# Product Discontinuation Notices

No. 2012121E

## Discontinuation Notice of USB flash memory. Model FZ-MEM1G

#### Difference from discontinued product

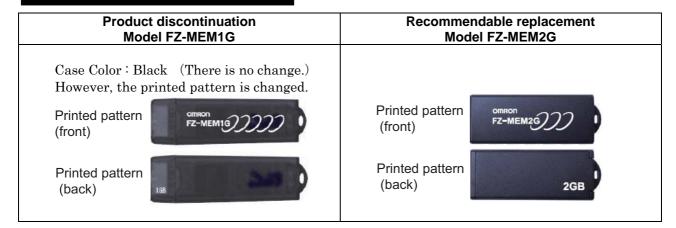
Please note that the dimensions have changed.

Model	Body Color	Dimen sions	Wire connection	Mounting Dimensions		Operation ratings	Operation methods
FZ-MEM2G	*		**		*	*	**
